UNITED STATES PATENT AND TRADEMARK OFFICE

| APPLICATION NO. | FILING DATE | FIRST NAMED INVENTOR | ATTORNEY DOCKET NO. | CONFIRMATION NO. |
|---|-------------|----------------------|---------------------|------------------|
| 10/566,816 | 04/24/2006 | Jean-Claude Hubert | ARNIPAU03US | 9025 |

Office Action Summary

FIG. 6

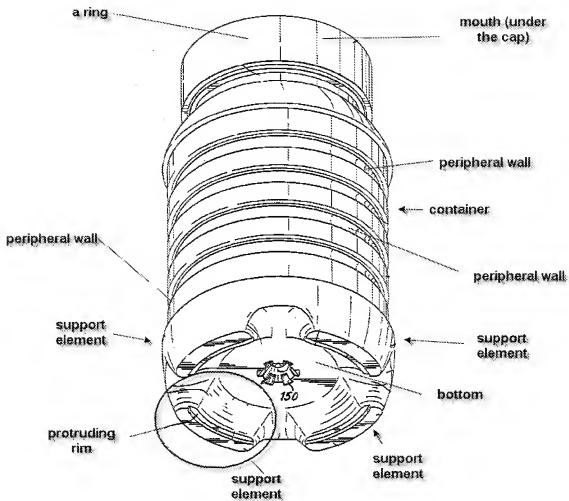
a. Regarding claim 1, Tobias teaches a container (in annotated Fig. 6) for containing foodstuff. The container comprises a bottom (in annotated Fig. 6); a peripheral wall (in annotated Fig. 6), integral with the bottom and extends upward from the bottom and defines a mouth opening (in annotated Fig. 6). There is at least one support element (in annotated Fig. 6) arranged on the bottom at a position corresponding to the edge of the mouth opening, such that in a stacked position of at least two identical containers, the support element of the first container rests on the edge of the mouth opening of the second container (it is inherent that the lid rests on the edge of the mouth opening and the second container rests on the lid and the edge of the mouth opening in Tobias Fig. 5 at 56) and at least three support elements (in the above annotated Fig. 6) in the form of a bulge are formed in the bottom and side wall and protrude beyond the bottom plane. The Tobias reference DIFFERS in that it does not teach a foil layer in between the mouth and the lid that is on the edge of the mouth of the container. Attention however is directed to Fuller which discloses another stackable container. The stackable container has a foil seal (Fuller, Fig. 1 at 20) over the container's mouth and the cap or lid resting on the containers opening over the foil seal. Therefore, it would have been obvious to one of ordinary skill

- b. Regarding claim 2, Tobias teaches the bulges protrude beyond the peripheral wall (in the above annotated Fig. 6).
- c. Regarding claim 4, Tobias teaches the at least three support elements (in the above annotated Fig. 6) are evenly distributed over the bottom.
- d. Regarding claim 5, Tobias teaches the support element comprises a protruding rim or support ridge (in the above annotated Fig. 6).
- e. Regarding claim 6, Tobias teaches the support element is arranged inside the produced part of the peripheral wall (in the above annotated Fig 9).
- f. Regarding claim 7, Tobias teaches the bottom and the peripheral wall integral with the bottom are connected via a rounded off corner portion or bumper (Tobias, Fig. 9 at 122).
